REPORT AMENDED BY STAFF 3/13/86 and 3/27/86  
**CITY PLANNING COMMISSION**

**LOCATION:** 500 Haggin Avenue

**APPLC. NO.** P85-444 **MEETING DATE** March 13<sup>27</sup>, 1986 **ITEM NO** 25

**APPLC. NO.** P85-444      **MEETING DATE** December 19, 1985      **ITEM NO** 21

SITE PLAN  
1-28-86

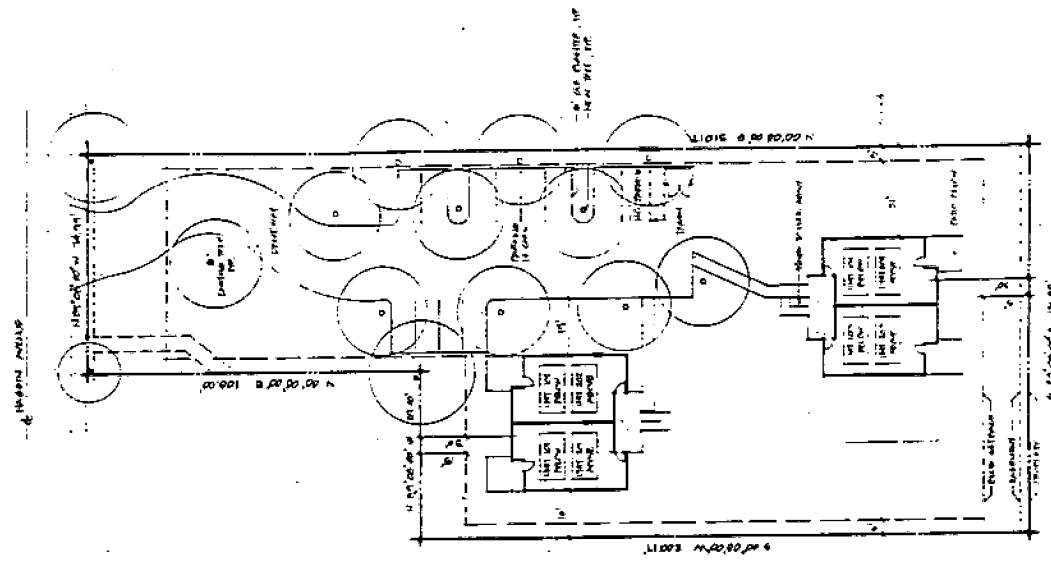
- C. The applicant's site development plans indicate that the eight units will be constructed as duplexes. Three of the units would be located to the rear of the site, with the parking area located at the middle of the site. The proposed units will be constructed with T1-11 siding and composition shingle roof. Architecturally, the proposed units do provide a varying visual line. Staff has no objection to the materials or design of the units.
- D. Due to the proximity of a church to the east of the subject site and location of the adjacent multiple-family structure to the south, it would not be appropriate to subdivide the rear portion of the subject site and surrounding lots.

The alternative development of the site would be to design a mix of single and two-family structures in a deep lot development concept. To retain the single family character along Haggin Avenue, staff suggests that a single family dwelling be designed at the front portion of the lot adjacent to the driveway entrance. The relocation of one unit will also provide more open space between the duplex units to the rear.

To provide closer access to the units, staff suggests the parking area be moved farther toward the south end of the property. The applicant, therefore, must submit a revised site plan to the Planning Director indicating the suggested design changes prior to issuance of building permits.

1. Minimum 24-foot wide driveway (reduce to 22 feet wide; 25-foot behind sidewalk);
2. Straighten driveway.

1. The applicant shall relocate parking area toward the south end of subject site and construct one unit at the front of property at 25-foot setback. A revised site plan shall be submitted for staff review and approval indicating the revision prior to issuance of building permits.
2. The applicant shall comply with the 50 percent shading requirement for the parking area.
3. A maximum of eight units shall be constructed on the subject site.
4. The applicant shall comply with the applicable City driveway standards and shall satisfy all requirements of the Traffic Engineering Division.
5. The applicant shall provide eight covered and three uncovered parking spaces.
6. A complete landscaping and irrigation plan shall be submitted to staff for review and approval prior to the issuance of building permits.
